STAFF REPORT: 9/10/25 REGULAR MEETING PREPARED BY: E. THACKERY

APPLICATION NUMBER: HDC2025-00463

ADDRESS: 4011 TYLER

SCOPE: REPLACE WOOD WINDOWS AND STEEL WINDOWS WITH NEW VINYL WINDOWS

Window 4, interior, from application.

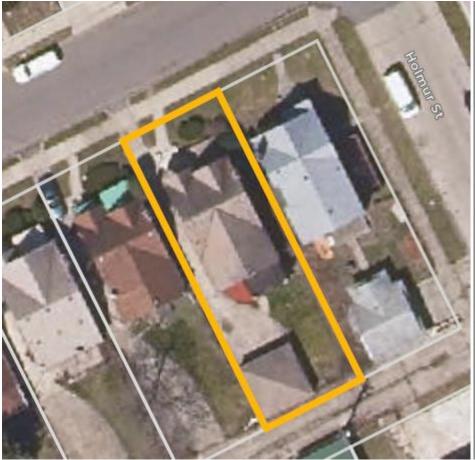
- O Staff can see some paint failure on the exteriors of the wood sashes, despite the aluminum storms, and some paint failure near the bottom center of both wood windows from the interior. Staff can't evaluate wood conditions from these photos, however.

- While more detailed photographs of each window's condition and/or an assessment from a window restoration professional might help provide more complete information for the commission to make their assessment about repairability, staff's current assessment based on available documentation is that these four windows are not beyond feasible repair.

- The proposed new windows will likely not be able to match the dimensions of the **wood** sashes' components like rails and stiles because vinyl is not as strong as older wood and as a result, the vinyl windows' structural members would likely be thicker. The existing wood windows are dimensional in the way the wood progressively steps down to meet the glass, both on the interior and the exterior, and in the dimensionality of the brickmold. Both of these elements on vinyl windows are typically flat. Another difference between the existing and the proposed is texture. The texture of the vinyl will cause it to have a plastic finish and sheen. The proposed vinyl color is unknown, but all of the existing windows are painted to blend in with the brick; a light-colored window would detract from the house's character.

3 is almost at the rear of the house and not very visible from the front and wood Window 4 is toward the rear of the house, right next to another house, and behind a fence/barrier from the sidewalk, it may be possible to argue that considering dimensions, profiles, finish, and placement, a substitute-material, double-hung window for a wood double-hung window specifically for Windows 3 and 4 might be appropriate if the existing windows are truly beyond repair. Vinyl, however, can't be that substitute material, in staff's opinion, even in these specific instances, since vinyl windows lack dimensionality, have a thick and flat appearance, and have a plastic-like sheen. Additionally, the sash color is an important consideration. The vinyl color proposed is unknown, but vinyl windows are typically white. As mentioned, this house's windows have dark sashes, so a light sash color like beige or white would be inappropriate. It is staff's opinion that if Windows 3 and 4 are beyond repair, because of their location and secondary importance, a non-vinyl substitute material that closely matched wood in design, color, texture, dimensionality, proportions, sheen, and color could be considered by the Standards and Guidelines and the National Park Service guidance.

- The existing historic windows proposed for replacement should therefore be retained and repaired in kind where necessary, as required by the Standards.
